RE: SUBMISSION TO SSD-79146716 - FOR PYMBLE LADIES' COLLEGE SECONDARY INNOVATION PRECINCT AT 20 AVON ROAD, PYMBLE

Ku-ring-gai Council's objection to SSD-79146716 - 20 Avon Road, Pymble (Pymble Ladies' College Secondary Innovation Precinct)

Figure 1: Viewpoint 04 photomontage from Avon Road (source: Urbis, Visual Impact Assessment)

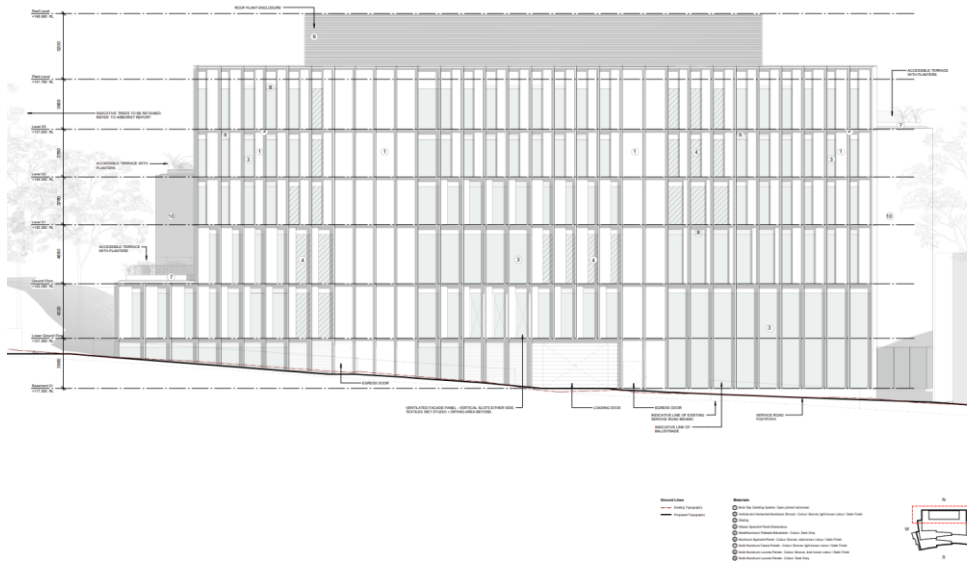
The submitted Visual Impact Assessment concludes that the overall visual effect on baseline conditions is 'low', noting that visibility of the proposal is limited, with mature and dense boundary vegetation screening all but small portions of the uppermost levels (refer to **Figure 1**).

However, this conclusion appears to rely on the assumption that all existing vegetation between the proposed development and Avon Road will be retained. In practice, a number of trees in this area are proposed for removal, including several large specimens identified as having 'High Retention Value' (refer to **Figure 2**). It is also noted that the area where tree removal is proposed sits at a higher ground level, which then slopes downward toward the site boundary (refer to **Figure 3 and 4**)—potentially increasing the visual exposure of the development.

Given the extent of proposed vegetation removal and the topographical context, there is concern that the building may be more visible from Avon Road and the surrounding low-density residential dwellings than currently indicated. This increased visibility may result in adverse visual and privacy impacts on neighbouring properties. Accordingly, further analysis is recommended, along with consideration of additional mitigation measures to address these potential impacts.

Figure 1a: Northern elevation of the proposed building

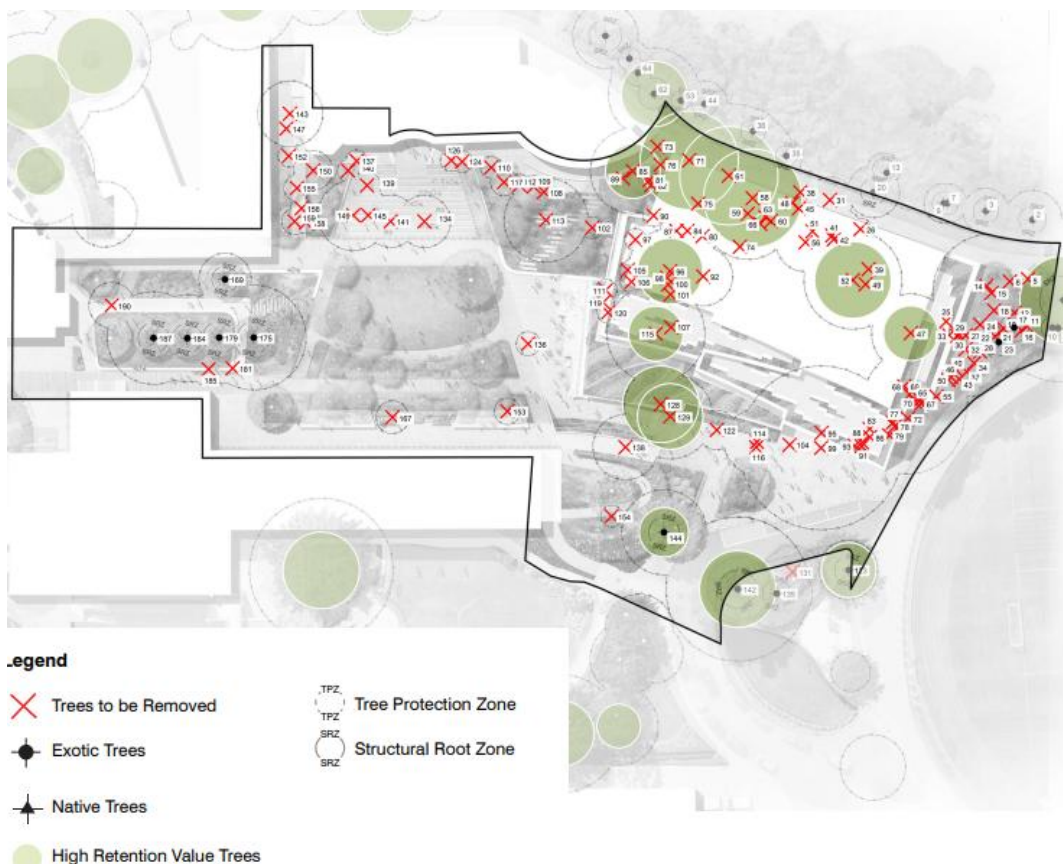
The proposed northern façade, which fronts Avon Road, comprises six storeys with an additional roof plant enclosure, resulting in a total building height of 29.68 metres (refer to **Figure 1a**). This represents a significant change in scale when compared to the adjacent R2-zoned low density residential dwellings along Avon Road. Furthermore, this façade lacks articulation or modulation to reduce its visual bulk. While this contrast in scale may be less of a concern if the building is not visible from Avon Road, this assumption requires careful consideration.

Figure 3: Elevation West (source 3XN, Architectural Plans)

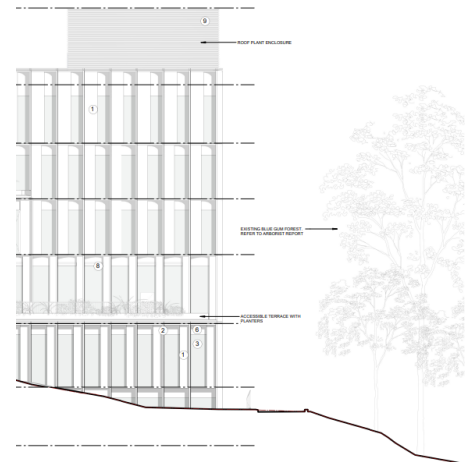
Further to the point above, the proposed roof plant enclosure may be highly visible from neighbouring low-density residential dwellings, particularly given its location directly adjacent to the northern boundary with no setback to reduce its visual prominence. The absence of a setback contributes to the perceived bulk and scale of the structure when viewed from Avon Road and surrounding properties (refer to Figure 3 and 4).

There is limited information provided regarding the design character and materiality of the enclosure. The Architectural Plans indicate the use of 'Solid Aluminium Louvre Panels – Colour: Dark Grey'. Depending on the final finish and detailing, this material could appear visually dominant within the surrounding residential context, particularly if viewed against a backdrop of lighter vegetation or sky.

It is recommended that consideration be given to introducing a setback from the northern boundary to reduce the visual impact of the plant enclosure. In addition, further design refinement is encouraged, including careful consideration of the enclosure's materiality, colour, and detailing, to ensure it does not present as a visually obtrusive element within the streetscape or from neighbouring properties.
